<b>Title of Change:</b>	Tube design change for TO220 single gauge package in Nantong Huada
<b>Proposed First Ship date:</b>	05 Mar 2021 or earlier if approved by customer
<b>Contact Information:</b>	Contact your local ON Semiconductor Sales Office or <a href="mailto:Jaroslav.Supina@onsemi.com">Jaroslav.Supina@onsemi.com</a>
<b>PCN Samples Contact:</b>	Contact your local ON Semiconductor Sales Office or < <a href="mailto:PCN.samples@onsemi.com">PCN.samples@onsemi.com</a> >. Sample requests are to be submitted no later than 30 days from the date of first notification, Initial PCN or Final PCN, for this change. Samples delivery timing will be subject to request date, sample quantity and special customer packing/label requirements.
<b>Additional Reliability Data:</b>	Contact your local ON Semiconductor Sales Office
<b>Type of Notification:</b>	This is a Final Product/Process Change Notification (FPCN) sent to customers. FPCNs are issued 90 days prior to implementation of the change. ON Semiconductor will consider this change accepted, unless an inquiry is made in writing within 30 days of delivery of this notice. To do so, contact <a href="mailto:PCN.Support@onsemi.com">PCN.Support@ons

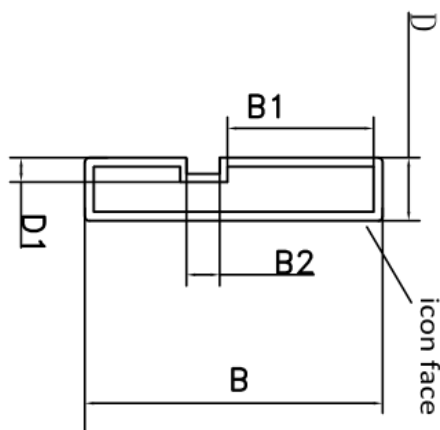
Dimensions B1 and D1 will be changed – see sectional view below.

Before Change Description	After Change Description
Dimension B1	17.4±0.25 mm	16.4-0/+0.5 mm
Dimension D1	2.65±0.25 mm	2.7±0.25 mm

Change of dimension B1 and D1 reduces the product movable space in tubes, less risk of rotated devices in tubes. No change for other dimensions.
